Product Change Notification: P-21-021453 PCN Date: 15-SEP-21

OMT Reed relay

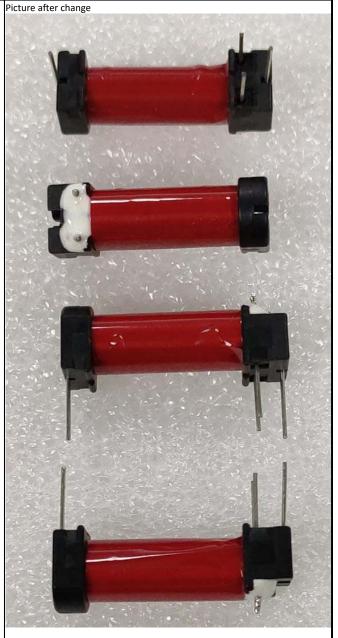
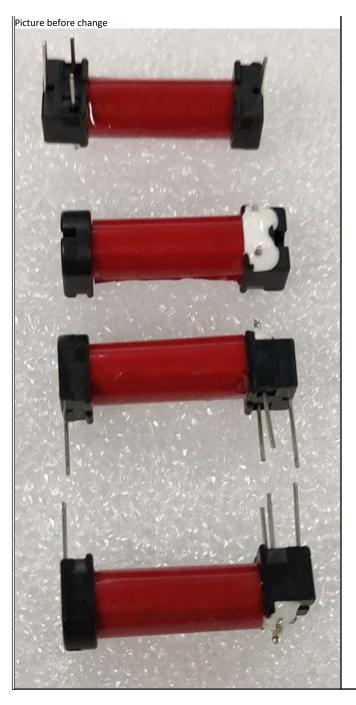
Change the material of epoxy which used to stick the coil tape, the appearance of tape is little affected, the change do not affect fit and function.

Reason for Changes:				
Product improvement. The original epoxy does not meet China Volatile Organic Compound (VOC) Regulation.				
Estimated Dates:				
Last Order Date (Obsolete Parts Only):	First Date To Ship (Changed Parts Only):			
	16-OCT-2021			
Last Ship Date (Obsolete Parts Only):	Last Date for Mixed Shipments: (Changed Parts Only):			
	16-DEC-2021
